# UNITED STATES PATENT AND TRADEMARK OFFICE

APPLICATION NO.	FILING DATE	FIRST NAMED INVENTOR	ATTORNEY DOCKET NO.	CONFIRMATION NO.
10/084,580	02/27/2002	Adya S. Tripathi	TRIPP030	6017
22434	7590	06/03/2005	EXAMINER	
BEYER WEAVER & THOMAS LLP			AGHDAM, FRESHTEH N	
P.O. BOX 70250			ART UNIT	PAPER NUMBER
OAKLAND, CA 94612-0250			2631

<b>Office Action Summary</b>	Application No. <span style="float: right;">6</span> 10/084,580	Applicant(s) TRIPATHI ET AL.	
	Examiner Freshteh N. Aghdam	Art Unit 2631

## **DETAILED ACTION**

Figure 2

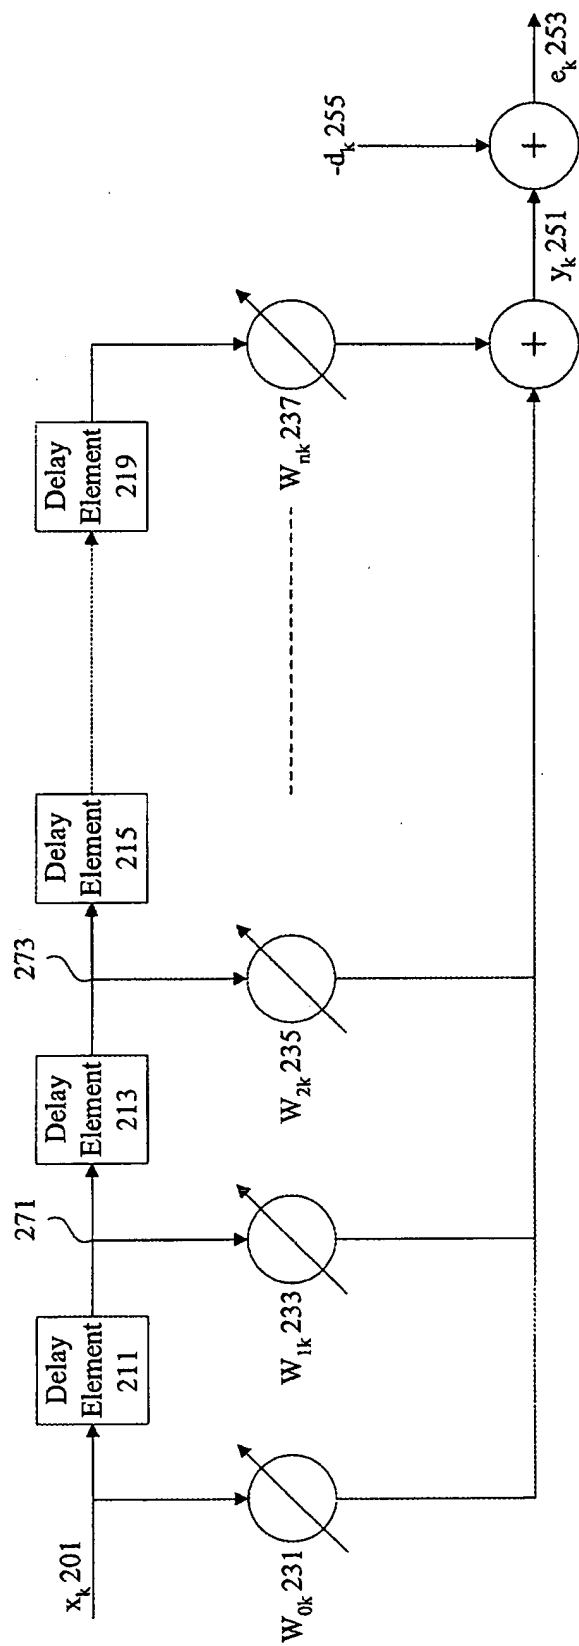
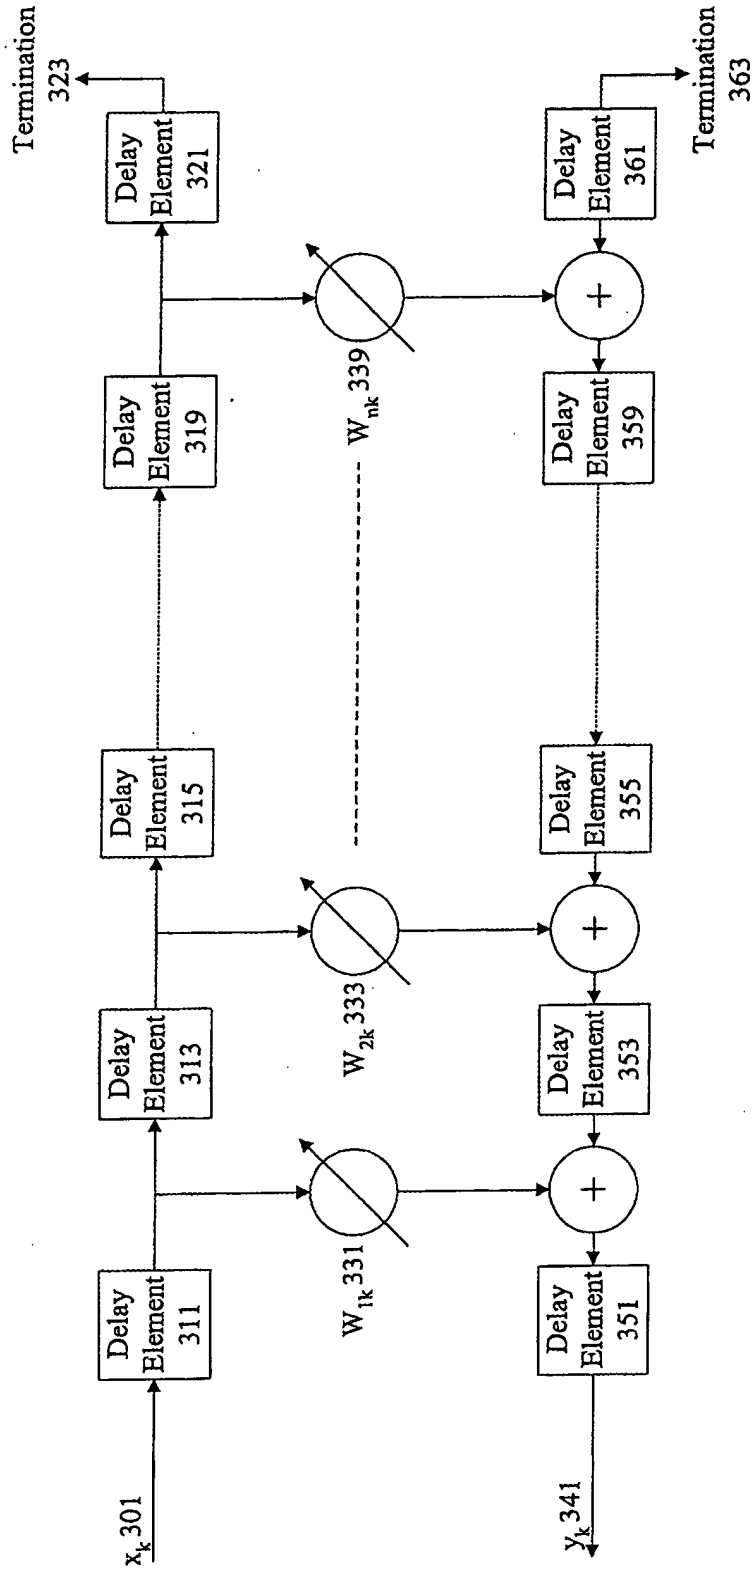
The drawings are objected to under 37 CFR 1.83(a) because they fail to show that figures 2 and 3 are prior art as described in the specification. Any structural detail that is essential for a proper understanding of the disclosed invention should be shown in the drawing. MPEP § 608.02(d). Corrected drawing sheets in compliance with 37 CFR 1.121(d) are required in reply to the Office action to avoid abandonment of the application. Any amended replacement-drawing sheet should include all of the figures appearing on the immediate prior version of the sheet, even if only one figure is being amended. The figure or figure number of an amended drawing should not be labeled as "amended." If a drawing figure is to be canceled, the appropriate figure must be removed from the replacement sheet, and where necessary, the remaining figures must be renumbered and appropriate changes made to the brief description of the several views of the drawings for consistency. Additional replacement sheets may be necessary to show the renumbering of the remaining figures. Each drawing sheet submitted after the filing date of an application must be labeled in the top margin as either "Replacement Sheet" or "New Sheet" pursuant to 37 CFR 1.121(d). If the examiner does not accept the changes, the applicant will be notified and informed of any required corrective action in the next Office action. The objection to the drawings will not be held in abeyance.

As to figures 2 and 3, the expression "prior art" is not recited to distinguish the drawings of the present invention from the existing devices.

Figure 3

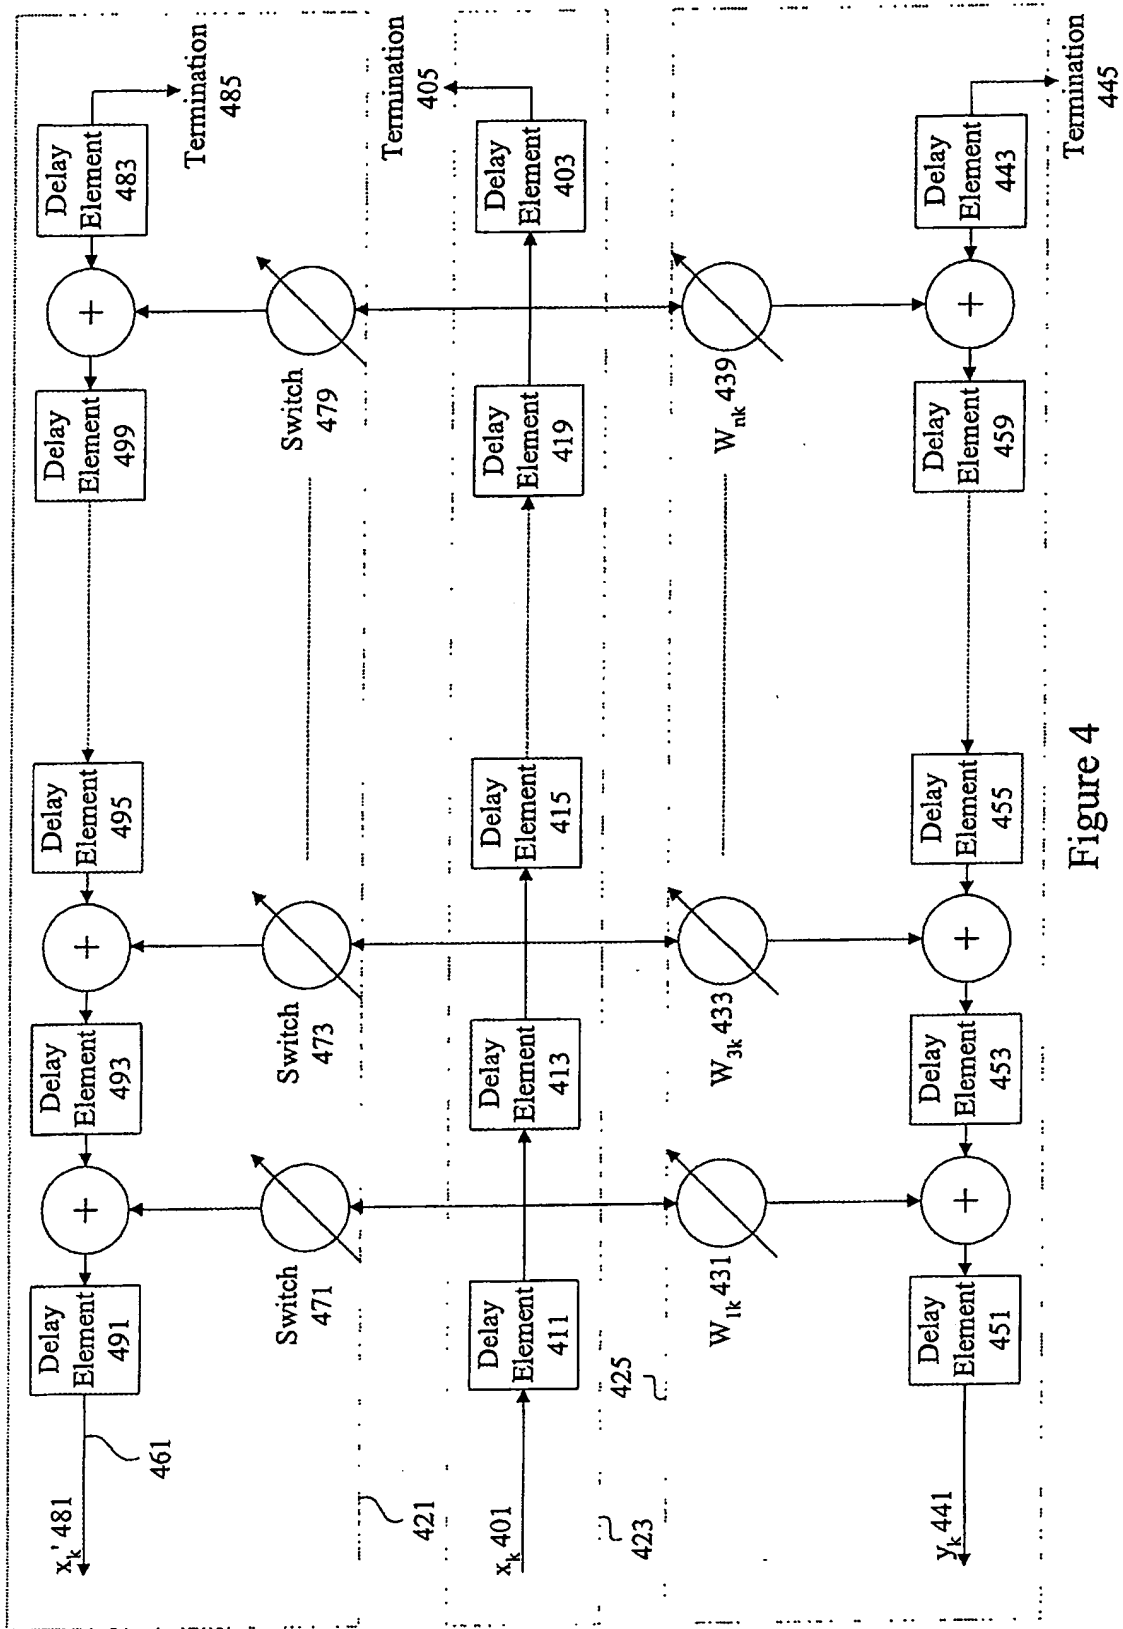
As to claims 1, 3, and 5, the admitted prior art teaches an adaptive equalizer comprising an input delay line including delay elements (Fig. 3, means 311-321), the input delay line is configured to receive an input signal (301) and provide intermediate signals, wherein intermediate signals are shifted representations of the input signal (i.e. time or phase shifting as recited in the specification see page 8, lines 27 and 28); a
